REVISED MARCH 30, 2022 PER FIRST CITY REVIEW – C.L. White

SITE UTILITY & LANDSCAPING PLAN
FOR
NEW BUILDING ADDITION
SHERWIN-WILLIAMS PAINT STORE
PREPARED FOR
LIONBERGER CONSTRUCTION CO.
SITUATE 610 CONNECTICUT AVENUE, NE
CITY OF ROANOKE, VIRGINIA

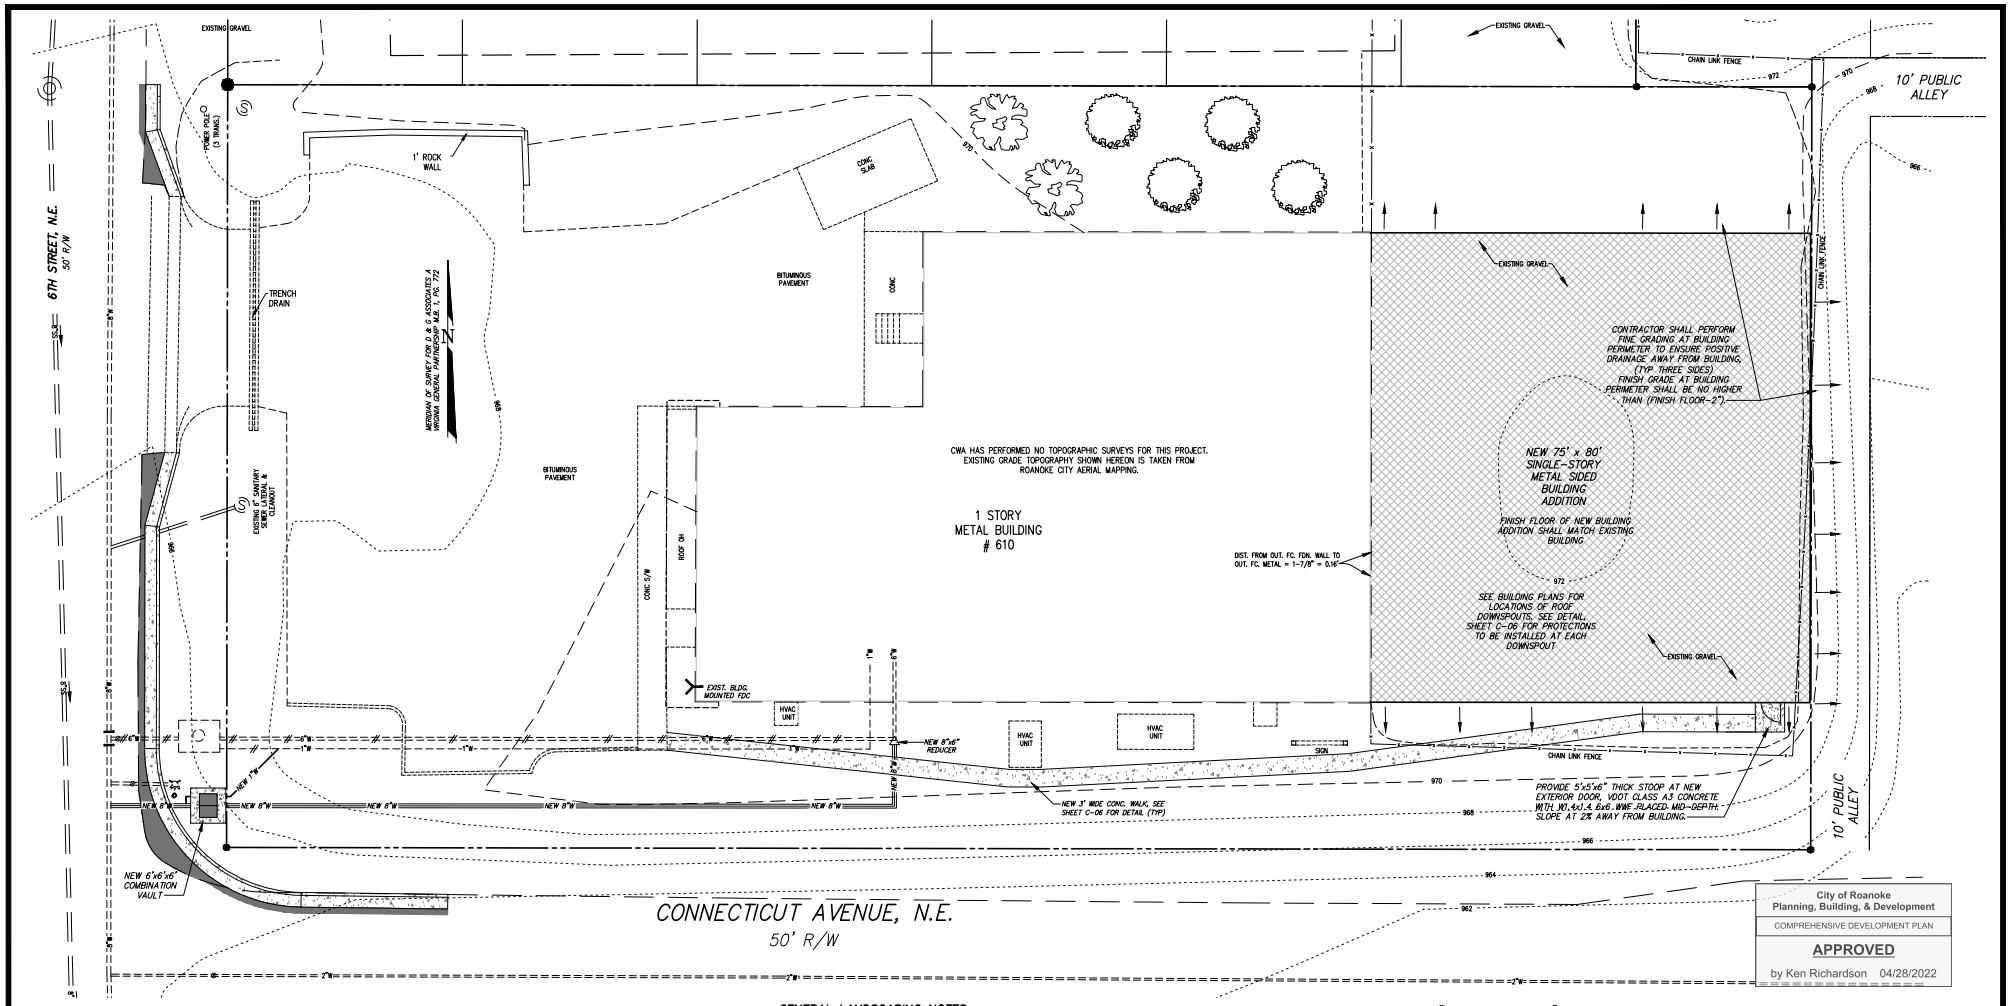
REVISED REMOVAL REQUIREMENTS OF EXISTING 6-INCH LINE

ADDED REQUIREMENTS OF NOTE #6

IT IS REQUIRED TO PROVIDE A MINIMUM 10% CANOPY COVERAGE FOR THE DISTURBED AREA: 9,957 SF (10%) = 996 SF CANOPY REQD. — REVISED CANOPY REQM'TS

REVISED COUNT & SPECIES

UPON ENERGIZING NEW FIRE AND DOMESTIC LINES AS DESCRIBED BELOW, REMOVE EXISTING VAULT IN ITS ENTIRETY AND ABANDON AT MAIN. REMOVE ALL 6-INCH WATERLINE BETWEEN VAULT AND 8-INCH MAIN, REMOVE GATE VALVE AND VALVE BOX, REMOVE TAPPING SLEEVE OR REDUCING TEE AT MAIN, AND SLEEVE 8-INCH MAIN. PROVIDE PAVEMENT REPLACEMENT AS REQUIRED.

5. THE EXISTING FIRE DEPARTMENT CONNECTION (FDC) MOUNTED ON THE SW CORNER OF THE BUILDING IS TO REMAIN, FED FROM THE HIGH-PRESSURE SIDE OF FIRE PUMP.
6. THE CONTRACTOR SHALL UPDATE THE FDC TO A 5-INCH "STORZ" CONNECTION WITH A 30-DEGREE ELBOW, AND SHALL PROVIDE AND INSTALL A KNOX BOX LOCKING 5-INCH STORZ CAP.

KEY	COMMON NAME – LATIN NAME	QTY	SIZE @ PLANTING	CANOPY PROVIDED
	Flowering Dogwood Cornus Florida	2	5" Min. Ht.	177 SF (1) = 354 SF
	Common Serviceberry Amelanchier Arborea	4	5" Min. Ht.	201 SF (4) = 804 SF
	TOTAL CANOPY PROVIDED			1,158 SF
